Serial No. 05-457
ESP/JDH
Docket No. 52-008

DOMINION NUCLEAR NORTH ANNA, LLC
NORTH ANNA EARLY SITE PERMIT APPLICATION
FINAL SAFETY EVALUATION REPORT REVIEW ITEMS AND REVISION 5 TO THE
NORTH ANNA ESP APPLICATION

Final Safety Evaluation Report Review Items

**Description of Changes in Revision 5
North Anna Early Site Permit Application**

Correction of Coordinates for ESP Site Footprint

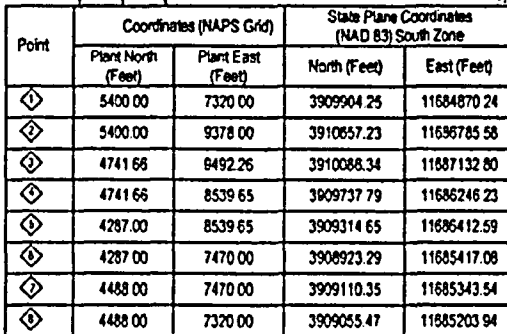
Coordinates for the ESP site footprint were submitted to the NRC in response to Draft Safety Evaluation Report (DSER) Open Item 2.4-1 (Dominion Letter 05-785B dated March 3, 2005).

As discussed in a July 5, 2005 conference call with NRC Staff, upon further review, it has been determined that the coordinates identified in Figure 1 of the DSER Open Item 2.4-1 response contained errors.

A corrected version of Figure 1 is provided on the next page.

None. Figure 1 on the next page is not included in the North Anna ESP Application.

Figure 2.5-55A

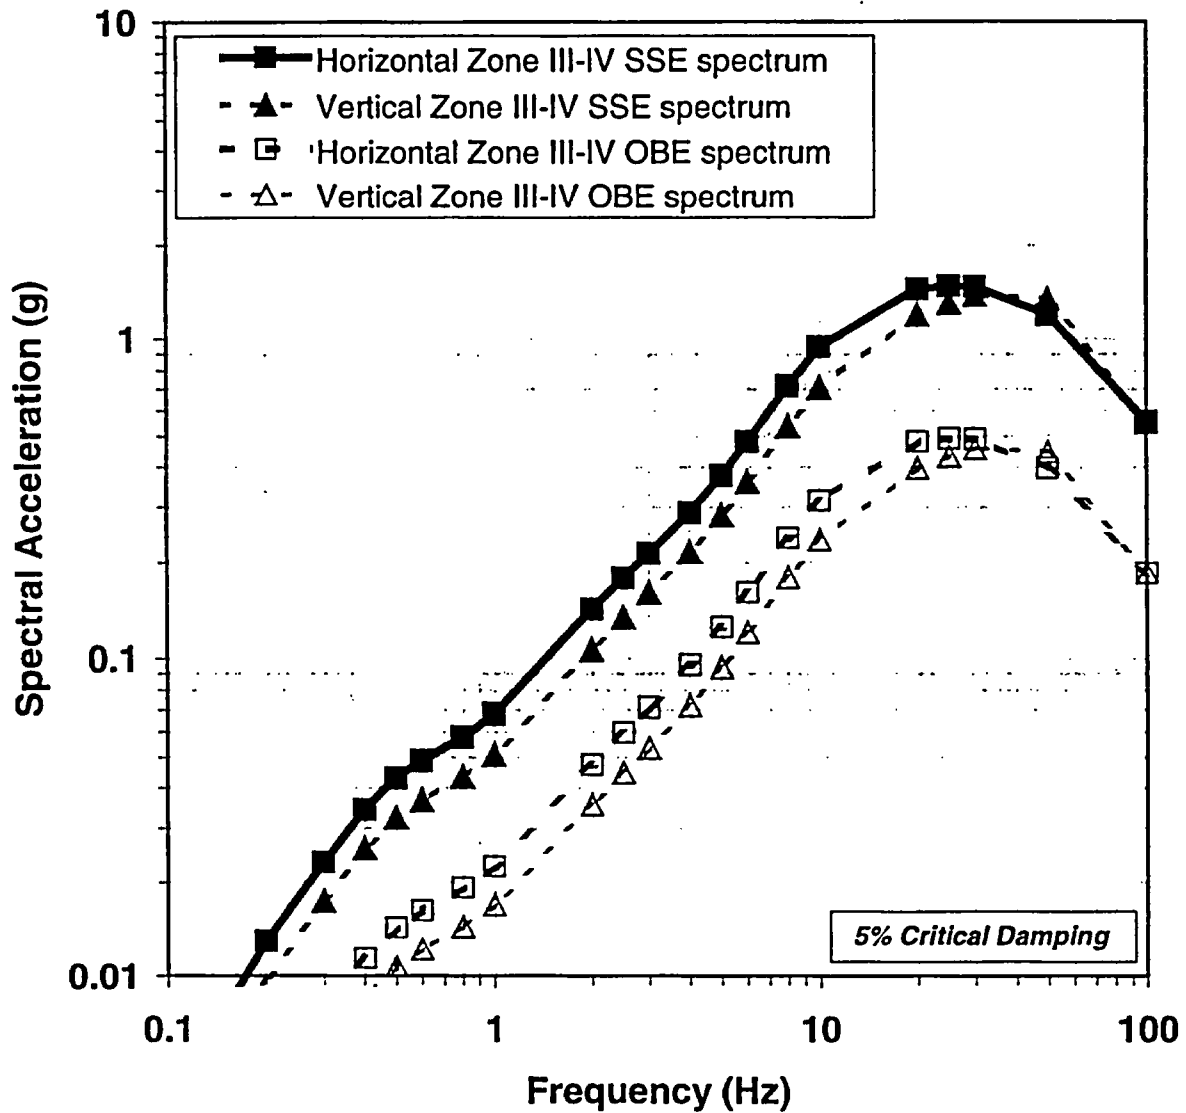
Incorrect Version of SSAR Figure 2.5-55A

In Dominion's response to DSER Open Item 2.5-2 (Dominion Letter 05-194 dated March 30, 2005), a new SSAR figure, Figure 2.5-55A, was included titled:

Figure 2.5-55A Selected Horizontal and Vertical OBE and SSE
Spectra for the Hypothetical Rock Outcrop Control
Point at the Top of Zone III-IV Material
(Representative Elevation 250 ft, 3300 ft/sec Shear
Wave Velocity)

Revision 4 of the North Anna ESP Application included an incorrect version of SSAR Figure 2.5-55A. (A duplicate copy of SSAR Figure 2.5-55 was inadvertently included as SSAR Figure 2.5-55A.)

The correct version of SSAR Figure 2.5-55A has been incorporated in Revision 5 of the ESP Application.

In Revision 5 of the ESP Application, SSAR Figure 2.5-55A has been replaced with the correct version shown on the next page.

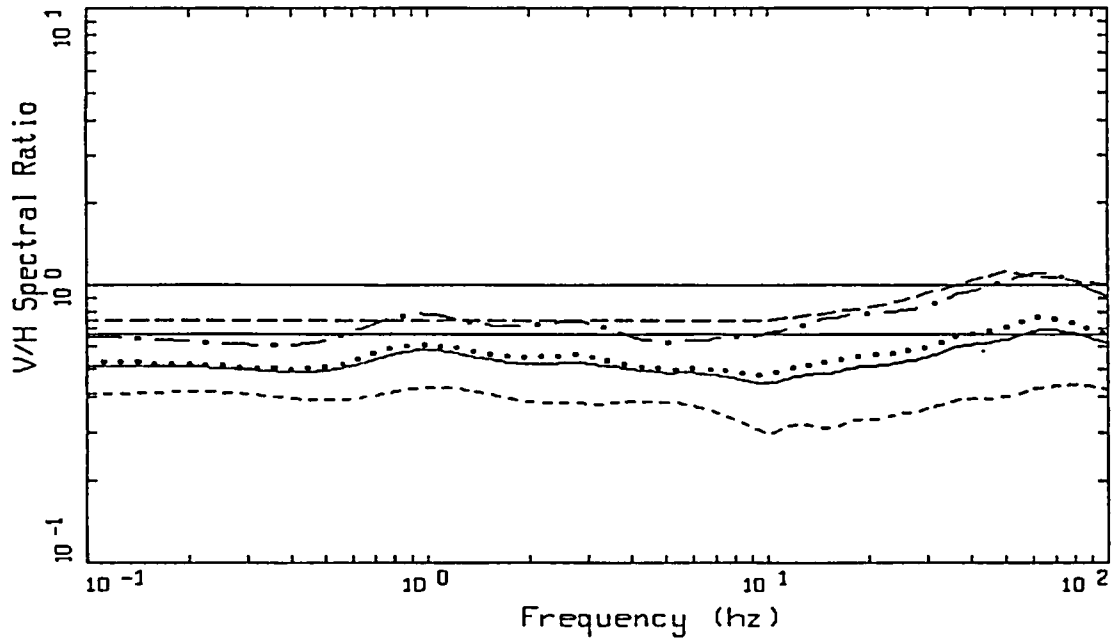
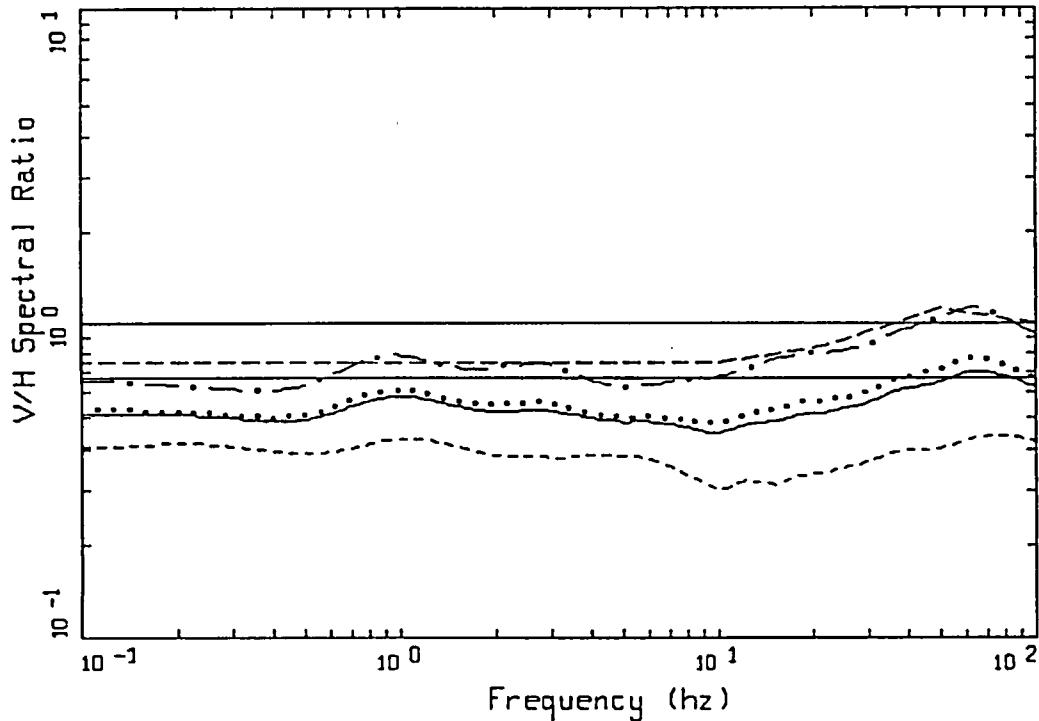
The statistical results of the V/H spectral ratios for the 0.5% damping level are shown in Figure 2. For comparison purposes, the V/H ratio for the 0.2g<PGA<0.5g bin from NUREG/CR-6728, which was used in SSAR Table 2.5-27A, is shown in Figure 2.

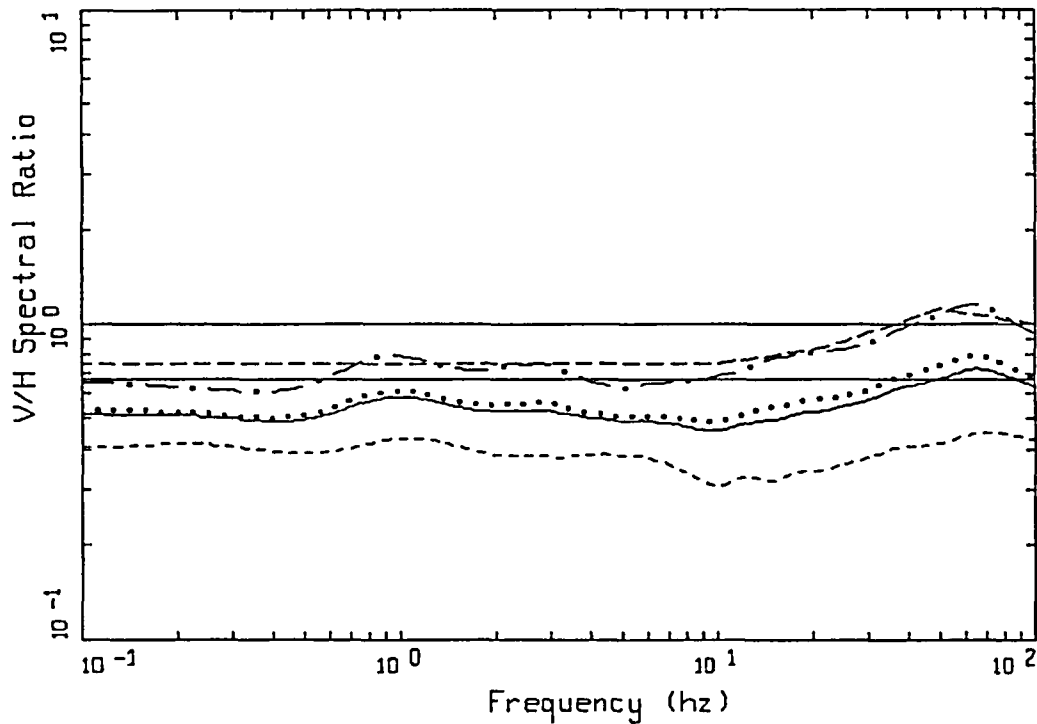
Similar plots for the additional damping levels of 1.0, 2.0, and 5.0% are shown in Figures 3, 4, and 5. The results for the base case damping level of 2.0% are tabulated in Table 2 for the 21 frequencies used in SSAR Table 2.5-27A.

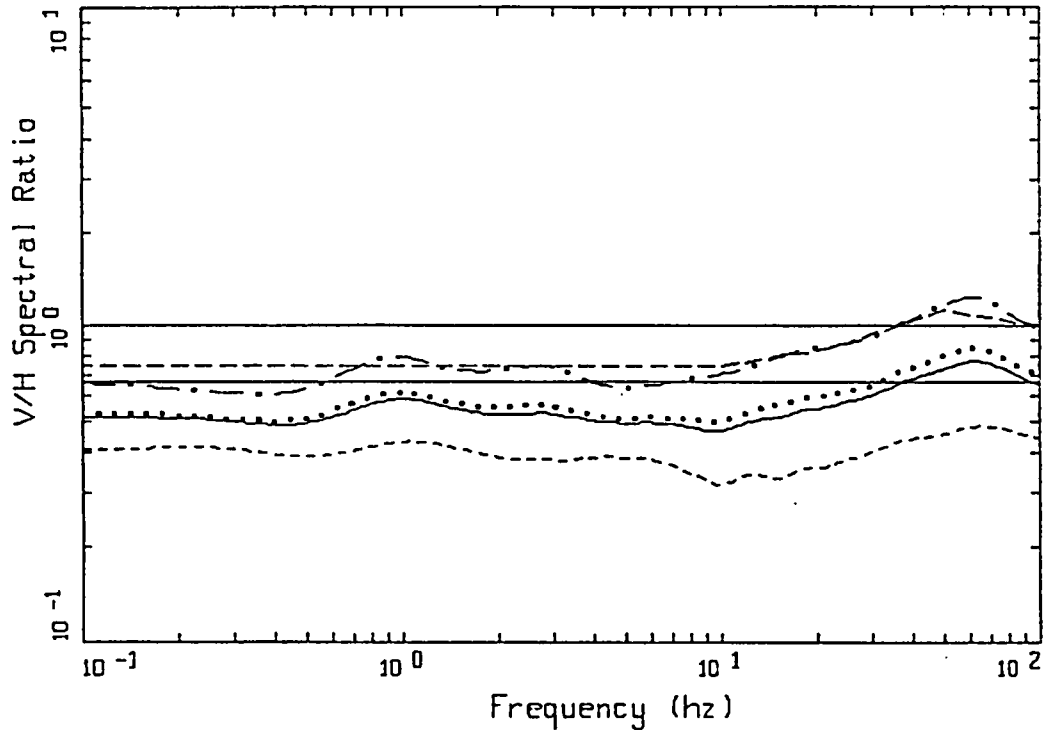
The 16th, 50th, and 84th percentiles and mean V/H ratios are shown in Figure 4 for the 2.0% damping case and listed in Table 2. For comparison, the V/H ratios from NUREG/CR-6728 for the 0.2g<PGA<0.5g case, which was used for SSAR Table 2.5-27A, are also shown in Figure 4 and listed in Table 2. On average, the mean V/H ratios from the site-specific analysis are approximately 30% lower (ranging from 18-35% lower) over the complete frequency range of 100 Hz to 0.1 Hz than the V/H ratios used in SSAR Table 2.5-27A. At the 84th percentile, the site-specific V/H ratio values are on average 8% lower (ranging from 19% lower to 5% higher) over the entire frequency range than the SSAR Table 2.5-27A V/H ratio values.

The site-specific analysis included the deaggregation information from the high frequency (i.e., 5-10 Hz) controlling earthquake only. If a more detailed analysis were performed, the deaggregation events from the low-frequency (i.e., 1-2.5 Hz) deaggregation would be included. In addition, the 5-10 Hz deaggregation events for distances greater than 75 km were included in the 75 km case. The above factors, if implemented, would result in smaller V/H ratios within the low-frequency range than those currently shown in Figure 4.

The comparison results provide justification that the V/H ratios given in NUREG/CR-6728 and used in SSAR Table 2.5-27A are appropriate for the North Anna ESP site. To maintain a hazard-consistent level in scaling the horizontal ground motions, the fractile level needed for the V/H ratio is between the 50th and 84th percentile. The exact percentile level would depend on frequency, site, design considerations, and judgment.
